**Point Beach Nuclear Plant**

License Amendment Request Number 247:  
Spent Fuel Pool Storage Criticality Control

### **LICENSE AMENDMENT REQUEST 247 SPENT FUEL POOL STORAGE CRITICALITY CONTROL**

Figure 3.7.12-1  
Fuel Assembly Burnup Requirement of "All-Cell" Storage Configuration

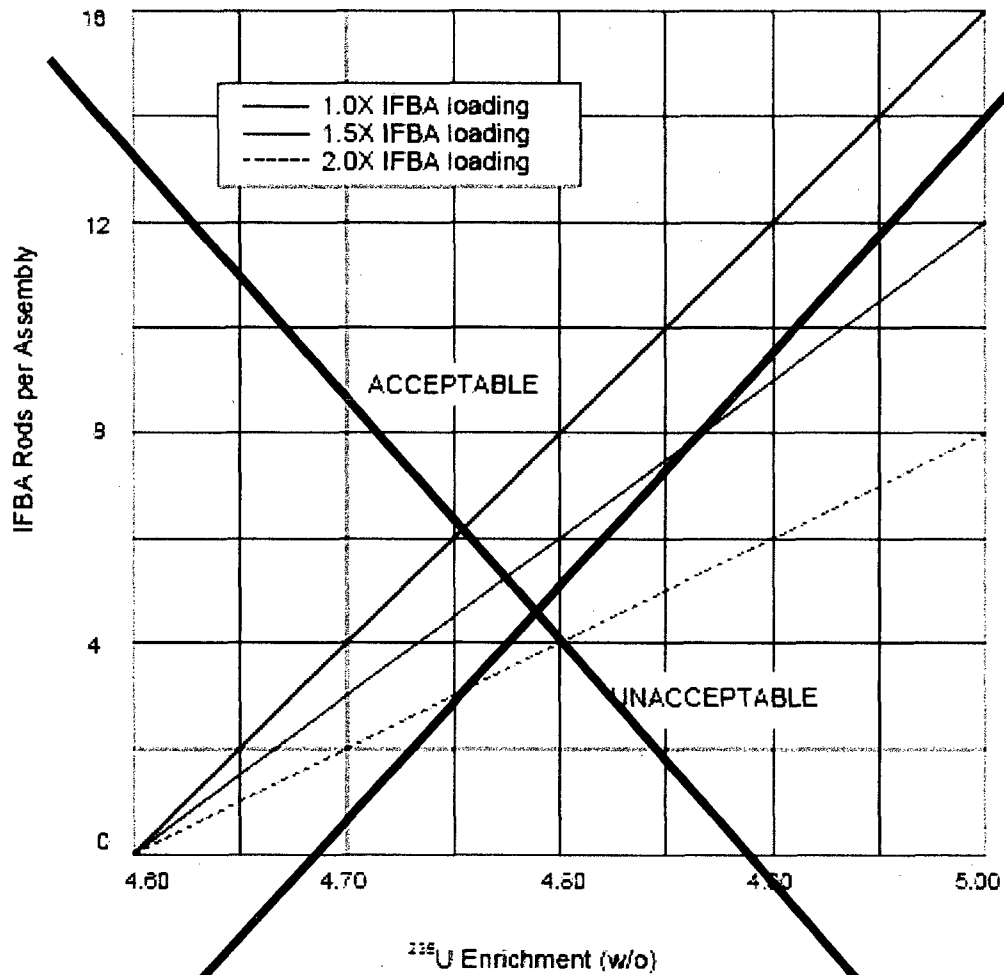
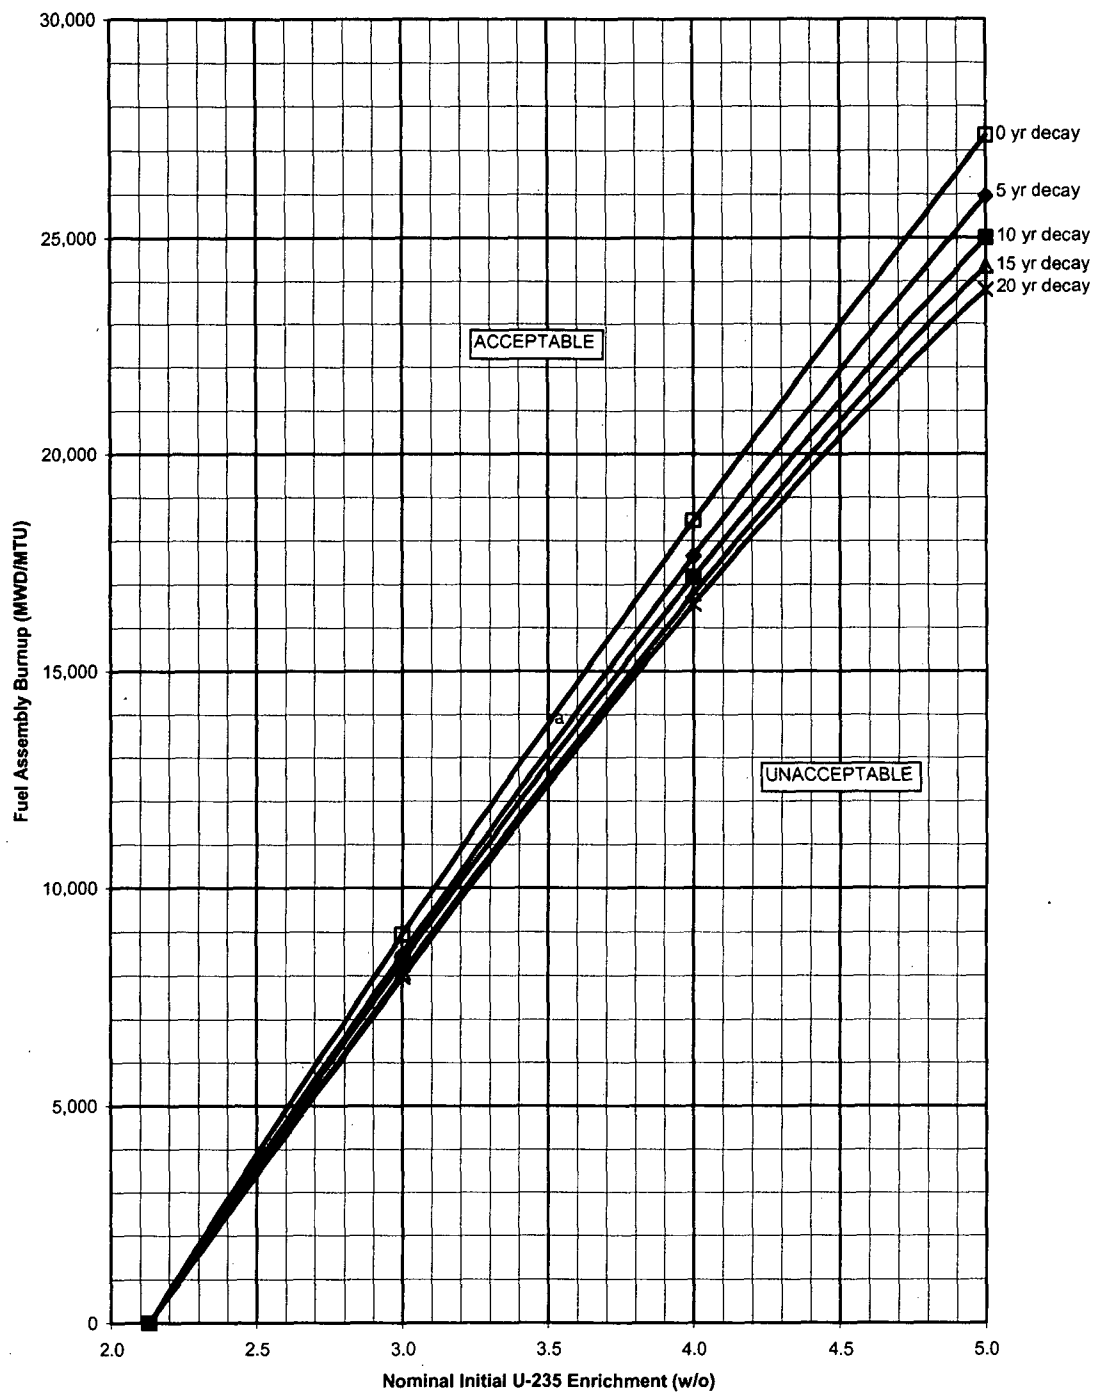
- Revise LCO 3.7.12 to remove LCO 3.7.12.a, which specifies a maximum fuel assembly initial enrichment of  $\leq 4.6$  w/o U-235 for fuel without IFBA.
- Revise LCO 3.7.12 to remove LCO 3.7.12.b, which refers to Figure 3.7.12-1 to specify the acceptable number, and poison material loadings, of the IFBA pins as a function of fuel assembly enrichment.
- Revise the text of LCO 3.7.12 and replace existing Figure 3.7.12-1 with a new figure that defines the acceptable range for fuel storage in the All-Cell configuration as a function of initial fuel assembly enrichment, burnup and decay time.
- Revise the text of LCO 3.7.12 to indicate that fuel must meet the conditions specified in Figure 3.7.12-1 or meet the storage configurations specified in Specification 4.3.1.1 by adding a reference to Specification 4.3.1.1.

- ~~a. Fuel assembly initial enrichment  $\leq 4.6\%$  w/o U-235; or~~
- ~~b. Fuel assembly contains Integral Fuel Burnable Absorber (IFBA) rods within the "acceptable" range of Figure 3.7.12-1.~~

The combination of initial enrichment, burnup and decay time of each fuel assembly stored in the spent fuel pool shall be within the Acceptable range of Figure 3.7.12-1 or in accordance with Specification 4.3.1.1.

0 yr decay =	$20e^3 - 573e^2 + 12811e - 24881$
5 yr decay =	$-34e^3 - 13e^2 + 10506e - 21990$
10 yr decay =	$-39e^3 - 36e^2 + 10537e - 21904$
15 yr decay =	$-108e^3 + 710e^2 + 7764e - 18715$
20 yr decay =	$-128e^3 + 865e^2 + 7269e - 18170$

Figure 4.3.1-1  
1-Out-of-4 for 5 w/o with no IFBA Storage Configuration

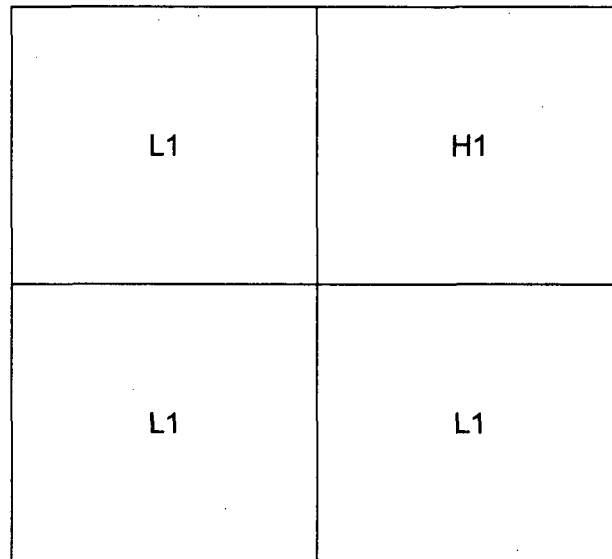
- f. New or spent fuel assemblies with a combination of discharge burnup, initial enrichment and decay time in the "Unacceptable" range of Figure 3.7.12-1 will be stored in compliance with Figures 4.3.1-1 through 4.3.1-8.

L1: Spent fuel assemblies in the "Acceptable" range of Figure 4.3.1-6.

Figure 4.3.1-6  
Spent Fuel Assembly Burnup Requirements for 1-Out-of-4 for 5.0 w/o with no IFBA

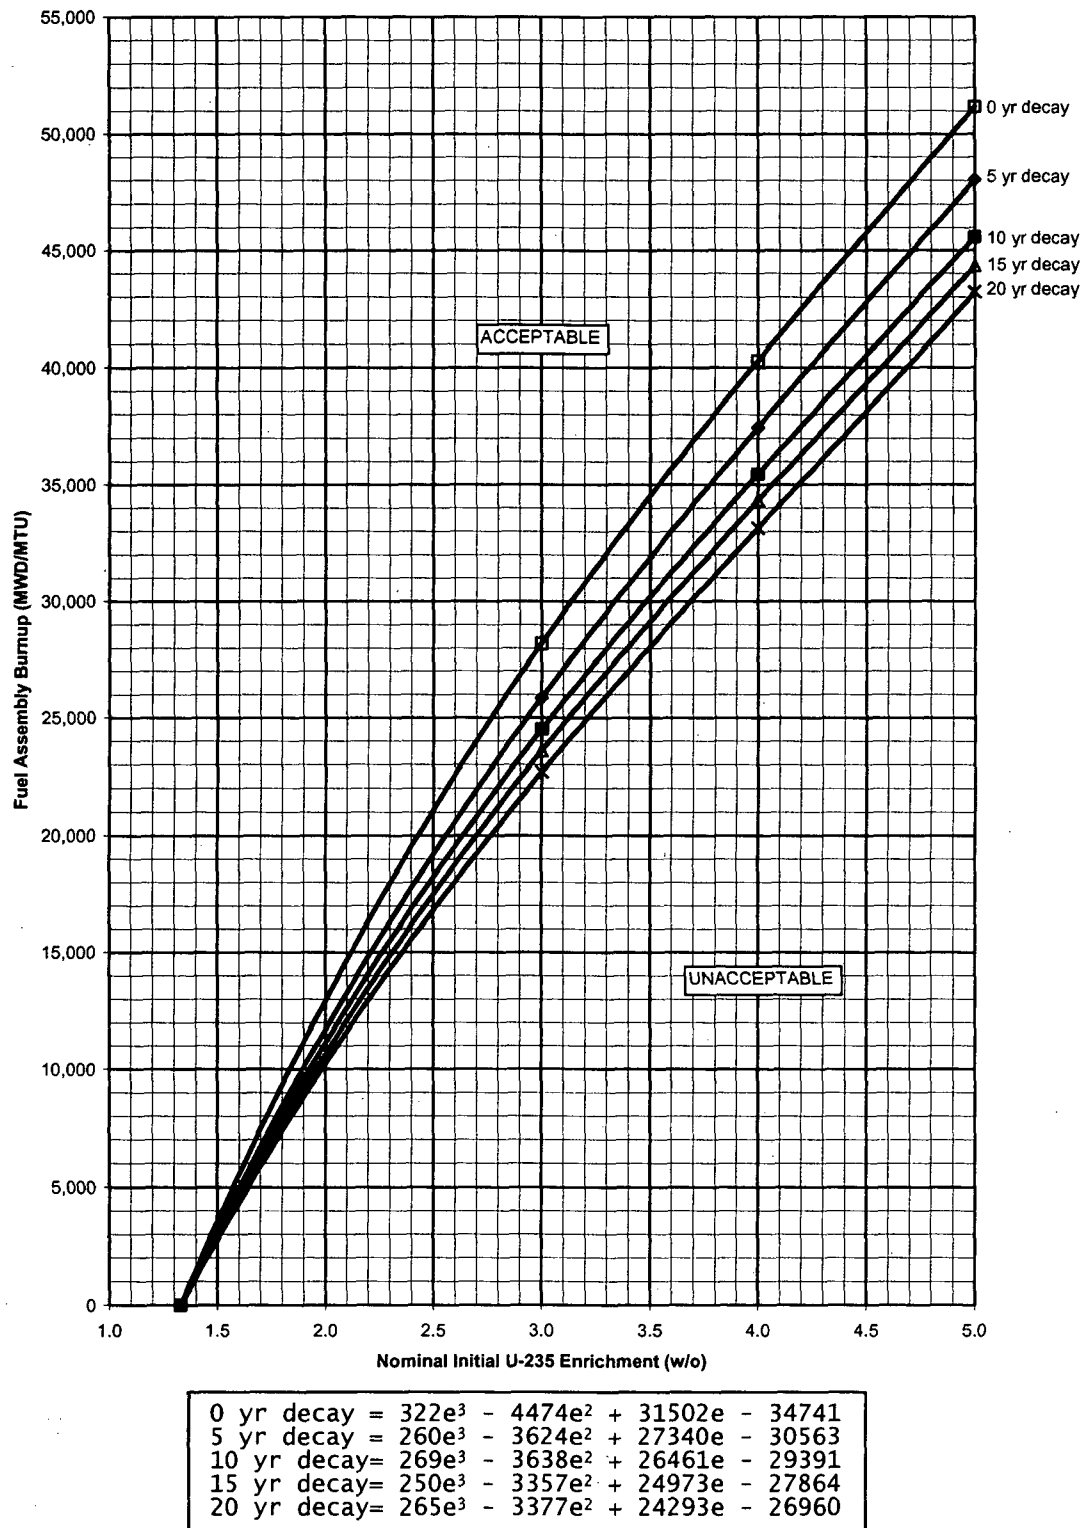
- Add a new Specification 4.3.1.1.e stating that new or spent fuel assemblies with a combination of discharge burnup, initial enrichment and decay time that is within in the "Acceptable" range of new Figure 3.7.12-1 may be allowed unrestricted storage in the fuel storage racks.
- Add a new Specification 4.3.1.1.f stating that new or spent fuel assemblies with a combination of discharge burnup, initial enrichment and decay time that is in the "Unacceptable" range of new Figure 3.7.12-1 will be stored in compliance with the additional requirements specified in new Figures 4.3.1-1 through 4.3.1-8.
